APPLICATION NO.	FILING DATE	FIRST NAMED INVENTOR	ATTORNEY DOCKET NO.	CONFIRMATION NO.
10/542,441	07/15/2005	Yaogang Chen	3410-0108PUS1	2781

Office Action Summary	Application No. 10/542,441	Applicant(s) CHEN ET AL.	
	Examiner NICHOLAS IEVA	Art Unit 2836

DETAILED ACTION

Figure A

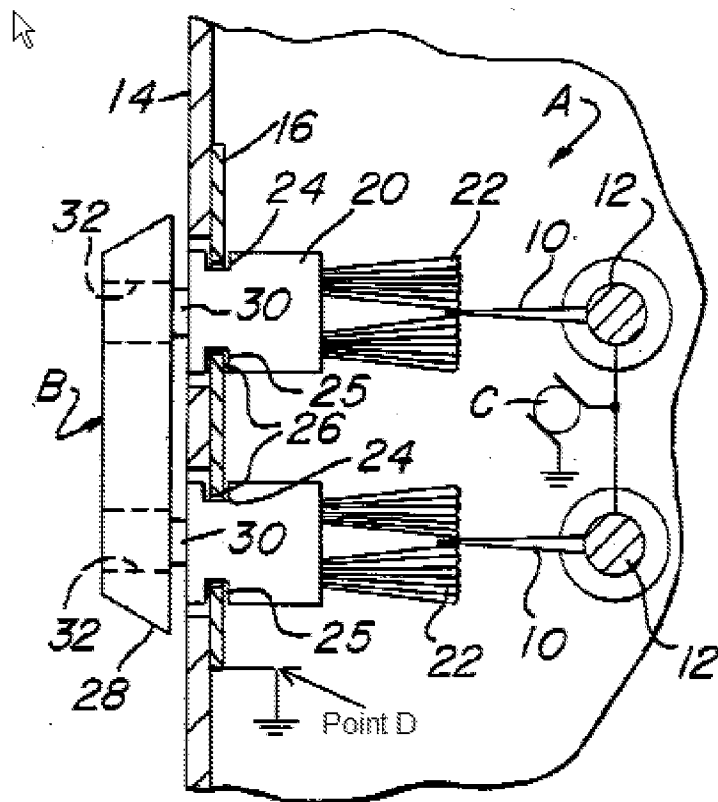
Consider **claim 12**, Rodrigo et al. teaches a generator, comprising a casing **14**, said casing having conductive protecting grille **16**, the conductive protecting grille is connected to a certain potential (ground); an interior circuit **C** within the casing; an ion emitting head (**12 and 10**) attached to the interior circuit; and a discharge resistance (resistance of wire between point D and ground), the discharge resistance is connected to the conductive protecting grille by a wire (the wire between the grill and point D) (Rodrigo; figures 1 and 2; column 2, line 60 – column 3, line 20; column 3, lines 54-67; and Figure A, below).

Consider **claim 14**, Rodrigo et al. teaches a generator, comprising a casing **14**, said casing having conductive protecting grille **16**, the conductive protecting grille is connected to a certain potential (ground); an interior circuit **C** within the casing; an ion emitting head (**12 and 10**) attached to the interior circuit and means for maintaining the potential of the conductive protecting grille (the resistance of wire between point D and ground) (Rodrigo; figures 1 and 2; column 2, line 60 – column 3, line 20; column 3, lines 54-67; and Figure A, above).

Consider **claim 15**, Rodrigo et al. teaches that the means for maintaining the potential of the conductive protecting grille is a discharge resistance (the resistance of wire between point D and ground) in the casing and is electrically connected to the conductive protecting grille via the wire between the grill and point D (Rodrigo; figures 1 and 2; and Figure A, above).

Rodrigo et al. teaches a conducting protective grille **16** that is connected to a certain potential (ground) and a discharge resistance (resistance of wire between point D and ground) that is spaced from said conducting protective grille via the wire between the grill and point D (Rodrigo; figures 1 and 2; column 2, line 60 – column 3, line 20; column 3, lines 54-67; and Figure A, above).

Consider **claim 11**, Rodrigo et al. teaches that the discharge resistance (resistance of wire between point D and ground) is connected to the conducting protective grille by a wire (the wire between the grille and point D) (Rodrigo; figures 1 and 2; and Figure A, above).
